### **CERTIFICATE OF APPROPRIATENESS**

**ISSUED: October 31, 2019**

James & Anna McDowell  
508 Remington Street  
Fort Collins, CO 80524

Subject: Egress Window Design  
508 Remington Street, Fort Collins, Colorado  
CTLJT Project Number: FC06453.001-501 L1

### BEAM AND JOIST DETAIL SOUTH OPENING

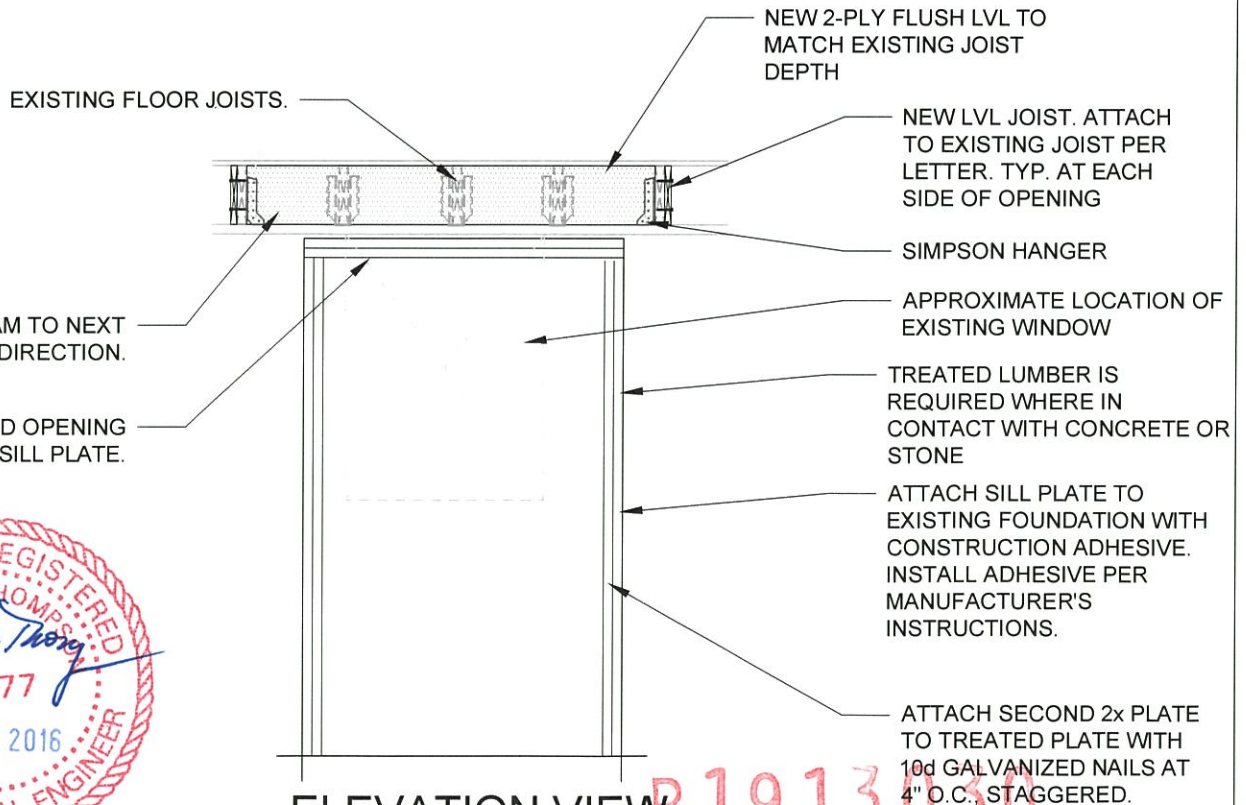
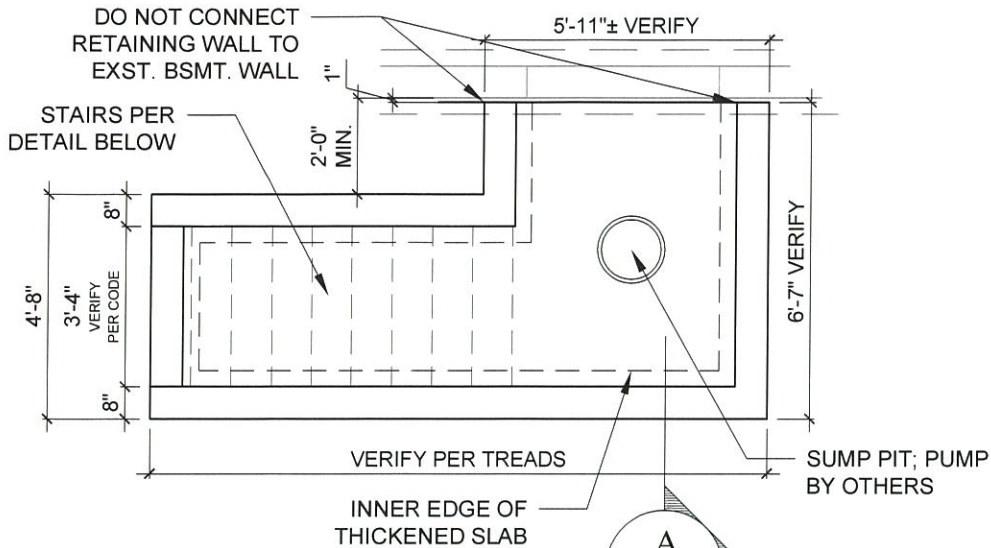
1. Remove the existing flush header beam in the basement and install a new LVL header that spans past the proposed door opening, extend the new beam to the next joist in both directions. The new LVL shall bear on the existing sill plate (See attachment 1).
2. Sister a new LVL joist of the same depth as the existing joist and extend back a minimum of 48". Attach to existing joist with (2) 1/4" dia. x 3 1/2" Simpson SDWS screws at 12" O.C. (See attachment 1)
3. The existing exterior stone lintel shall have a minimum of 4" bearing on existing stone on either side. Therefore, the new opening must be cut to ensure this minimum bearing.

SISTER A NEW LVL JOIST WITH A MINIMUM BACK SPAN OF 48". ATTACH TO EXISTING JOIST PER LETTER. NEW JOIST MUST BEAR ON SILL PLATE.

EXTEND NEW LVL TO DOUBLE JOIST AT EITHER SIDE OF OPENING.

CUT EXISTING JOIST AND ATTACH TO NEW FLUSH LVL WITH SIMPSON HANGER

NEW 2-PLY FLUSH LVL TO MATCH EXISTING JOIST DEPTH

**RETAINING WALL DETAIL**

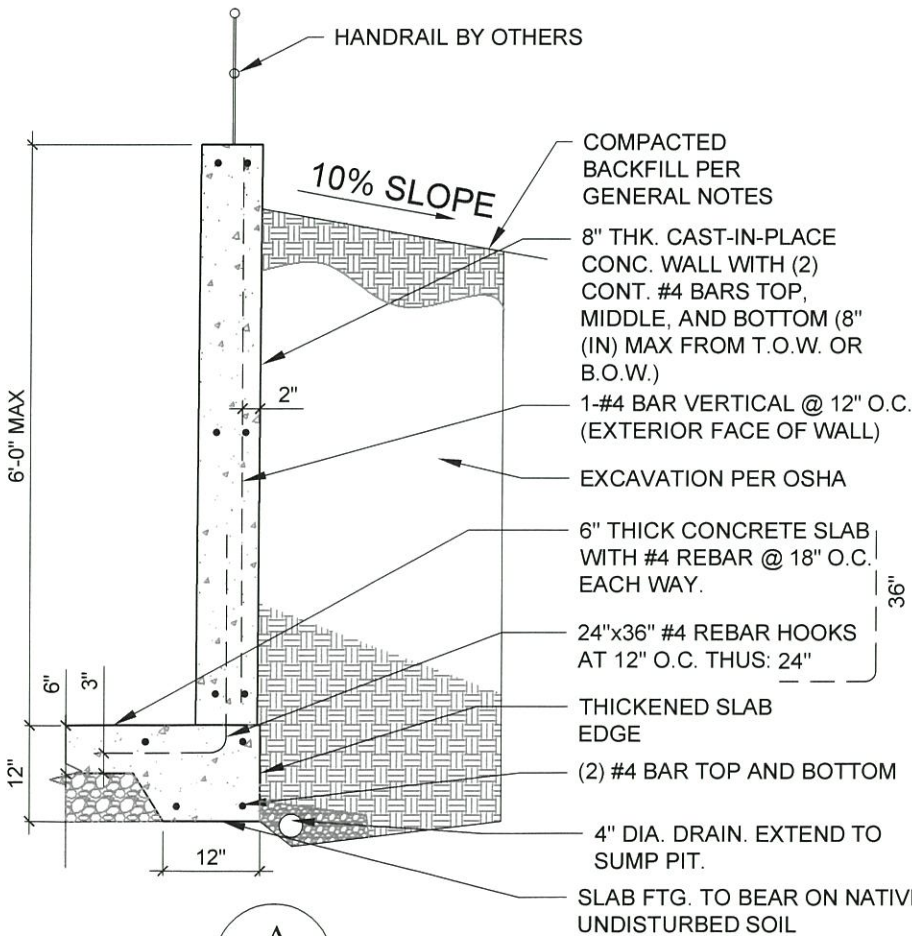
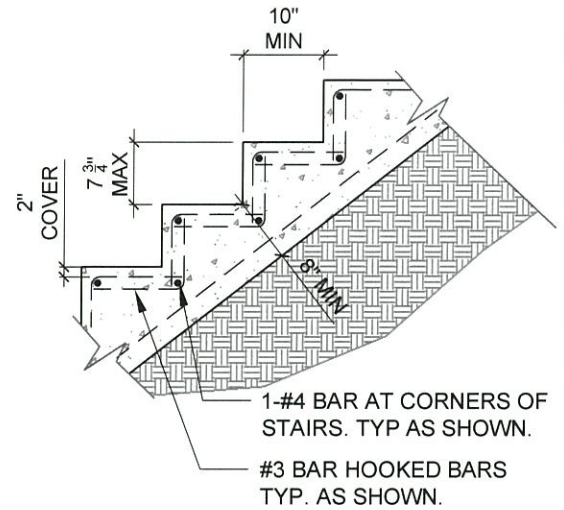
Also, attached are details for the proposed retaining wall around the new stair landing.

## NEW EGRESS WINDOW DETAIL

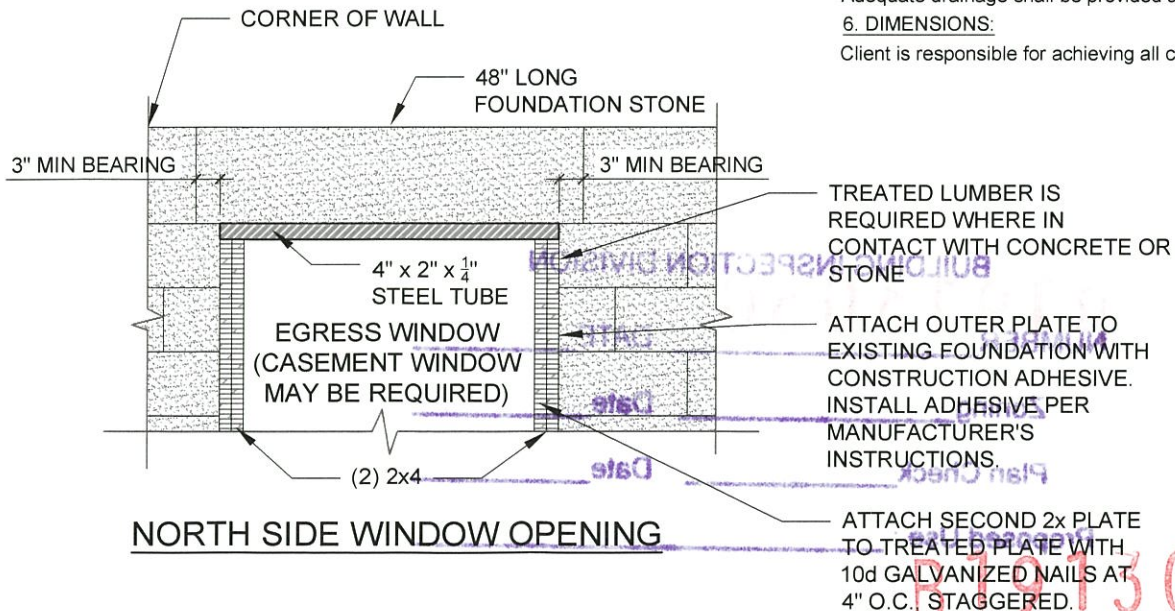
The location of the new egress window on the north basement wall is suitable to support an egress window. It must be located under the center of the 48" long foundation stone at the top of the wall. (See attachment 3).
